No. 27/52/2021-For & Emt
GOVERNMENT OF MANIPUR
SECRETARIAT: FORESTS, ENVIRONMENT & CC DEPARTMENT

Subject:- Proposal for diversion of 5.00 ha of forest land for Quarrying of Sandstone/Road metal, Murum and Shaly Earth in favour of M/s Sanjit Stone Mining & Crusher at Longa Koireng, Kangpokpi District, Manipur. Submission of Additional Information-reg.

Comments on the observations of Ministry of Environment, Forest & Climate Change, Govt. of India:

Sub : Proposal for diversion of 5.0 Ha of Forest Land for quarrying of sandstone / road metal at Murum and Shally Earth in favour of M/s Sanjit Stone Mining and Crusher at Long Koireng, Kangpokpi District, Manipur -reg.

FIGURE-1

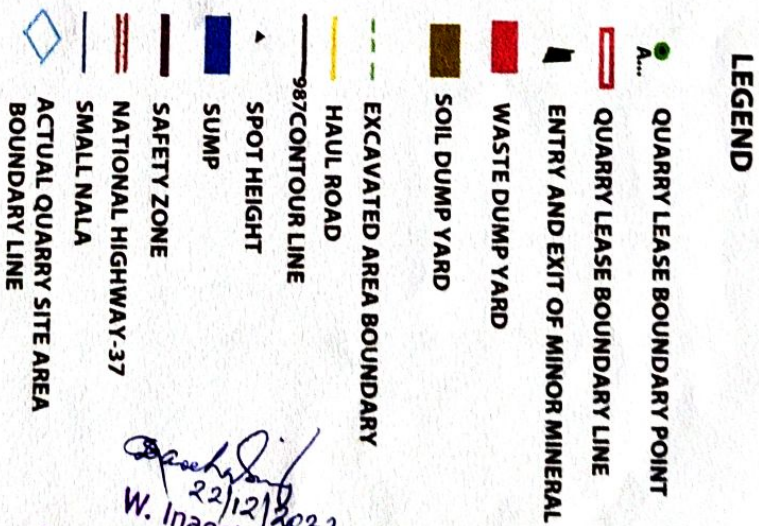
- As per details submitted in the proposal area of safety zone has been indicated as 0.404 ha while the same is considered as 0.58 ha in the Mining Plan.
Discrepancy in the land use needs to be rectified by the State Govt.

- No component pertaining to approach road has been proposed in the proposal.
The State Govt to submit comments on the same along with details of evacuation plan of the minor minerals from their lease area.

adjacent to the National Highway will not be effective in view of the above reason. Therefore, proposal for safety zone adjacent to the national highway has been removed thereby reduced the area to 0.404 Ha. The minor mineral will be evacuated through "Entry & Exit point located near Boundary Pillar I. The evacuation plan of minor mineral is shown in Figure-1 as appended.
6	No component pertaining to approach road has been proposed in the proposal. The State Govt to submit comments on the same along with details of evacuation plan of the minor minerals from their lease area.	The proposed quarrying lease area lies adjacent to National Highway - 37 (NH-37). The quarry site can be directly approached from NH-37 at Entry and Exit point near boundary point "I" as shown in Figure-1. Therefore, approach road was not proposed.

- v. As per Mining Plan, safety zone area was earmarked as 0.58 Ha. Out of this 0.58 Ha, around 0.18 Ha is along the NH-37 and the safety zone is almost non-existent and hence the safety zone has been reduced to 0.404 Ha.

- vi. The proposed quarrying lease lies adjacent to National Highway-37. The quarry site can be directly approached from NH-37 at entry and exit point near the Boundary Pillar I. Therefore, an approach road was not proposed.
